Oceana Gold (New Zealand) Limited
P O Box 5442
Moray Place
DUNEDIN 9058

RE: MACRAES PHASE 111 PROJECT-SECTION 92 REQUEST

Please find below our response to Questions 9a and 13a and to relevant sections of Questions 17 to 22.

Figure 1

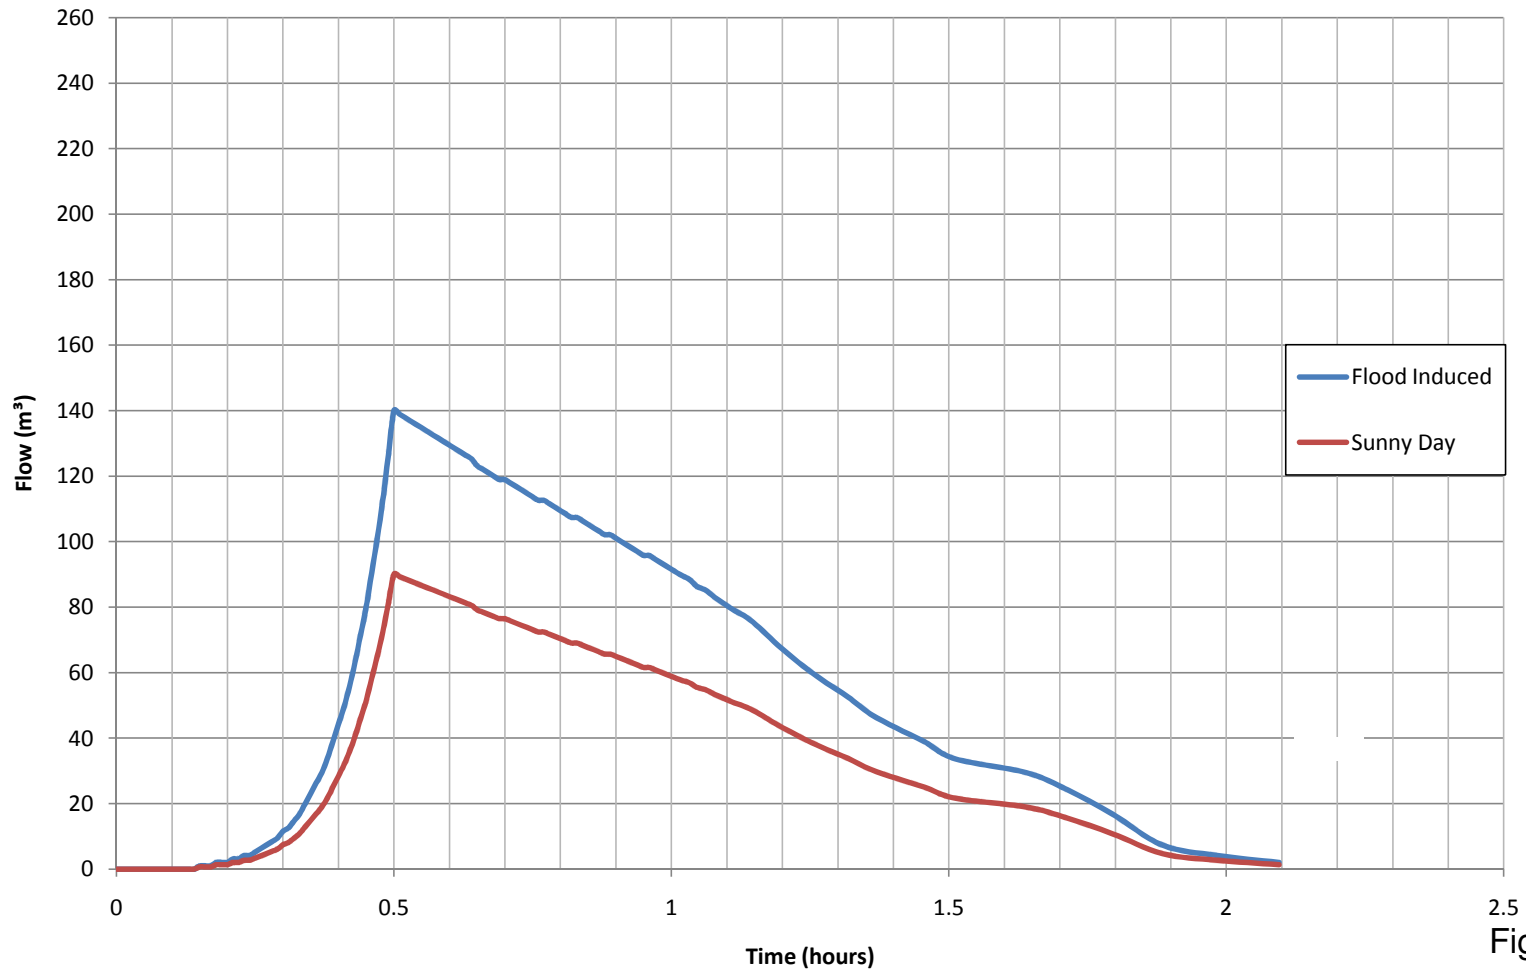
Q18.a) Please confirm how the flood attenuation in McCormicks Creek was estimated (98m³/s presented) and provide details of attenuation method and assumptions.

The 1 in 100 AEP flood flow in McCormicks Creek at the confluence with the Shag River was estimated to be 98m³/s. This location is of interest because of a road bridge on SH85 and two houses located nearby. The flood attenuation along the Tipperary and McCormicks Creeks was carried out by routing the breach hydrographs established for the Sunny Day and the Flood Induced failures through a HEC-RAS model. The hydrographs are presented in Figure 1.

Figure 3

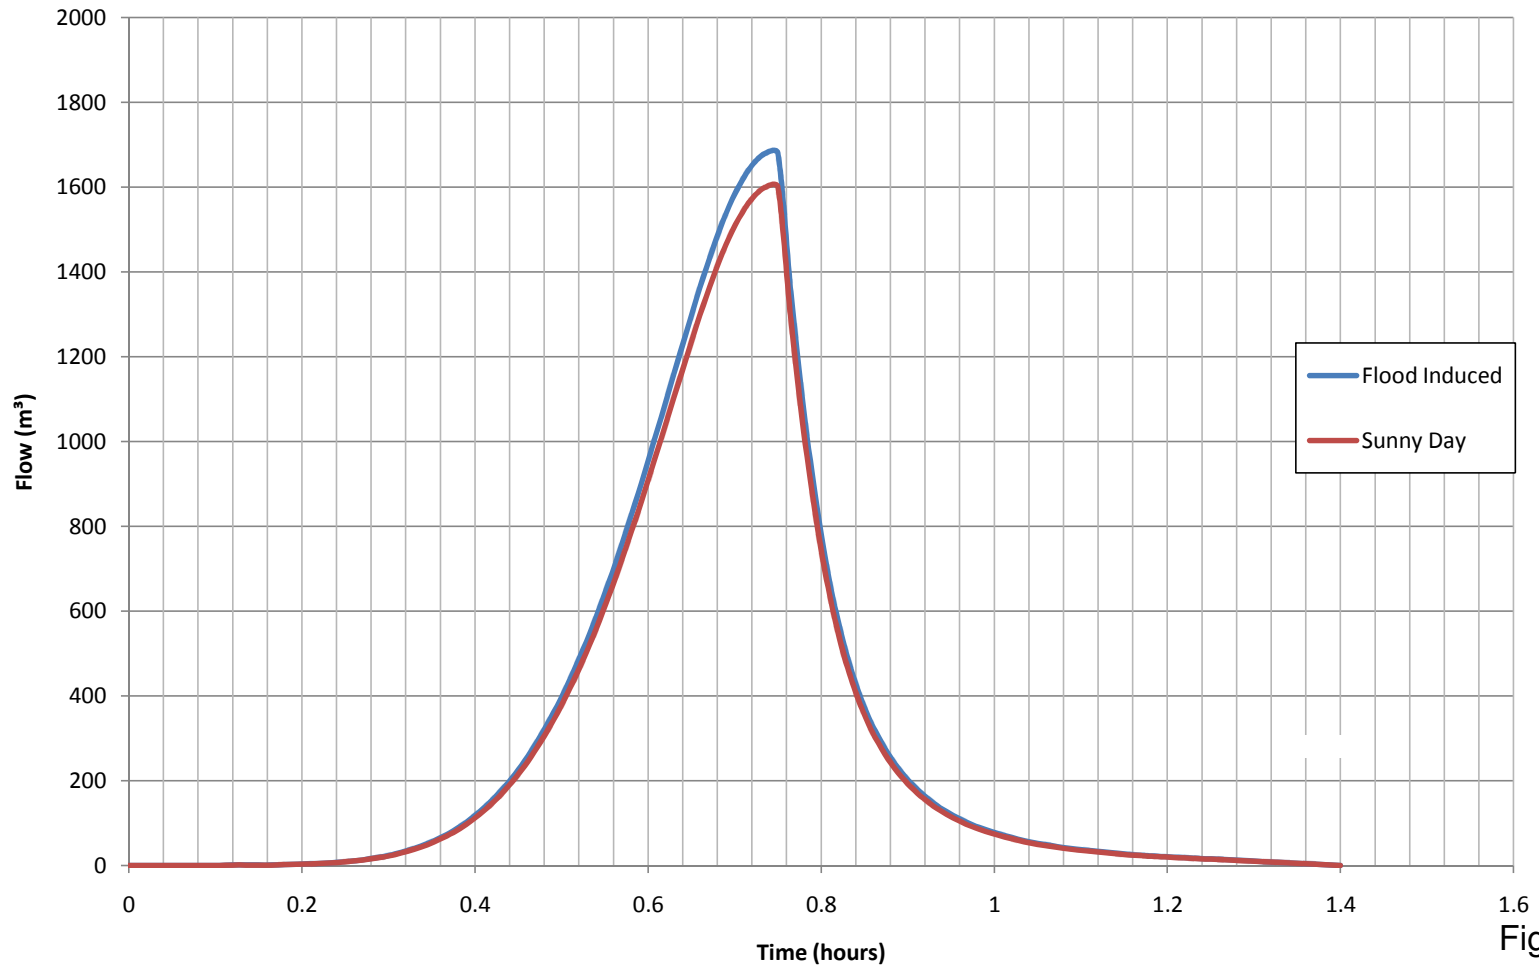
Q22. a) Please confirm how the flood attenuation in Deepdell Creek was estimated and provide details of attenuation method and assumptions.

The flood attenuation along Camp Creek, Deepdell Creek and Shag River was carried out by routing the breach hydrographs established for the Sunny Day and Flood Induced failures through a HEC-RAS Model. The hydrographs are presented in Figure 3.

Figure 4

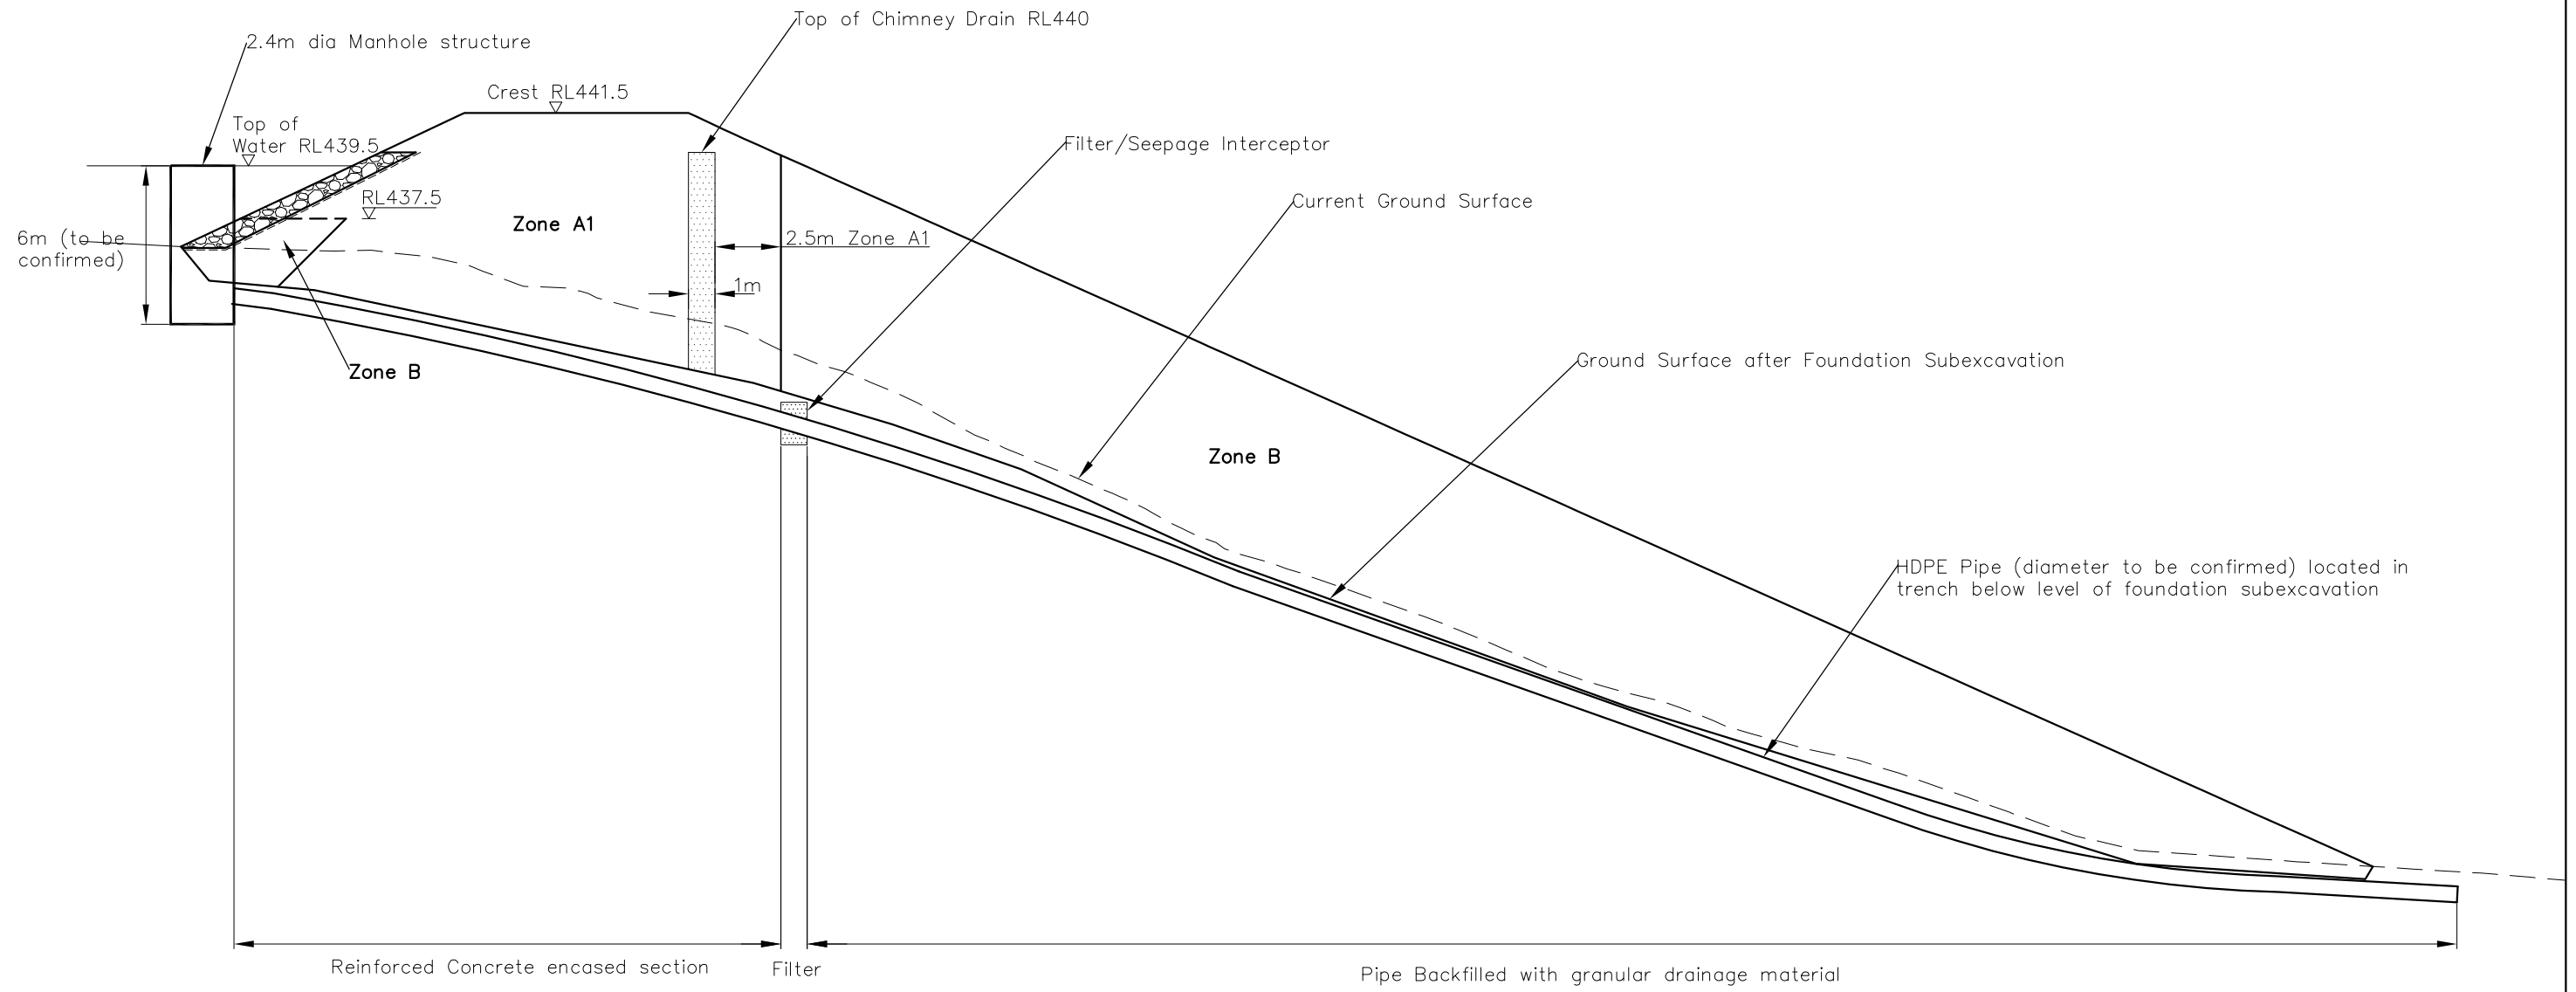
Q21.e) Please confirm the service spillway arrangements including routing the pipe through the abutment/embankment and present these on a drawing.

A long-section through the service spillway is shown in the attached Figure 4. It will be encapsulated in reinforced concrete to the downstream side of Zone A1. A filter/seepage interceptor drain will be located at the downstream end of the concrete encased section with granular drainage material around the pipe where it is located beneath Zone B.

Figure 5

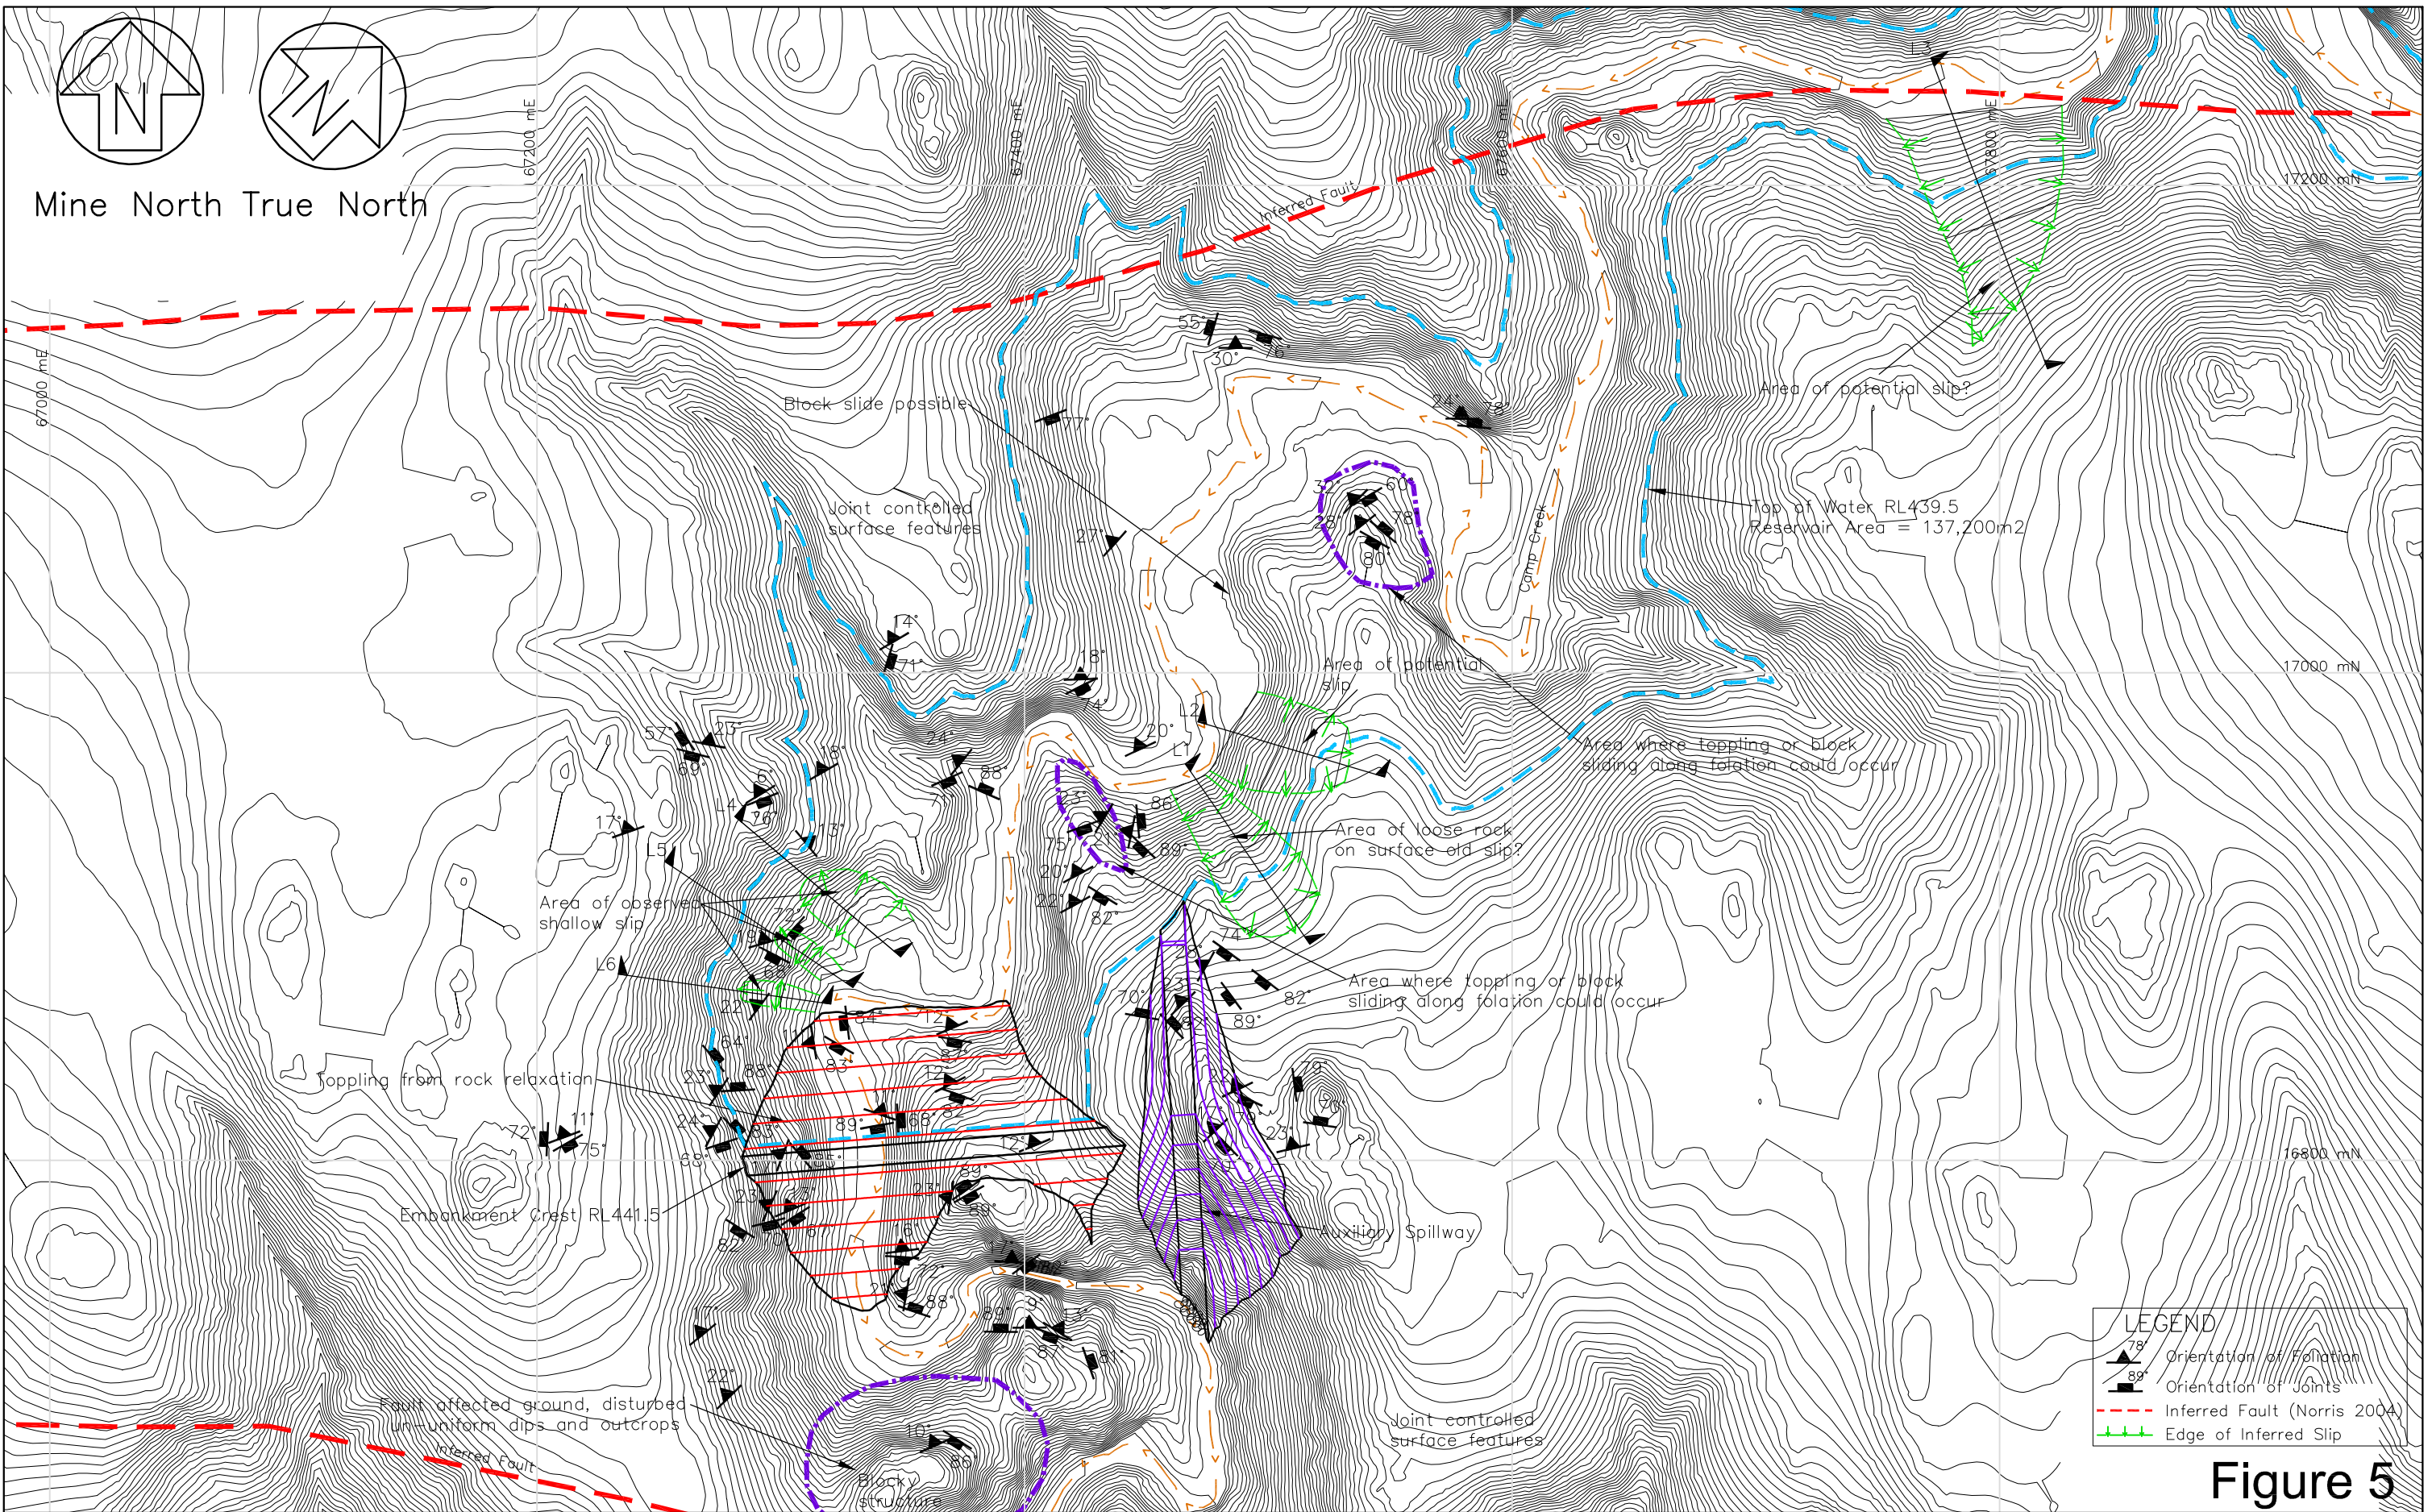
Q21. c) Provide details on the effects of the proposed reservoir on slope stability in the reservoir inundation area, and the assessed consequences of slope failure into the reservoir on the dam structure.

We have undertaken an assessment of the potential for reservoir induced land instability. The field mapping and review of aerial photographs indicated the presence of six landslides around the reservoir. Most are shown in Figure 6 of the Camp Creek Technical Report. They are also shown in the attached Figure 5 and are labelled as landslides L1 to L6. Inferred cross sections through the landslides are shown in Figures 6 and 7. All the landslides are located either completely or partially below the top normal reservoir water level. In all cases the toes of the landslides are at the bottom of the reservoir. A summary of the landslides is given in Table 1 (below) together with an assessment of the volume of each landslide. The main concern is with slopes on the southern side of the reservoir which are flatter than on the northern side due to foliation dipping to the north. The most significant landslides (L1 and L2) are about 130m and 170m respectively upstream of the dam on the south side of the reservoir. L3, the third largest potential landslide is located over 500m upstream of the dam. Landslides L4, L5 and L6 are much smaller (less than 750m³) but are located immediately upstream of the dam on the north side of the reservoir.

Landslide (refer Figure 5)	Estimated Volume (m ³)
L1	7,900
L2	5,800
L3	3,800
L4	740
L5	330
L6	290
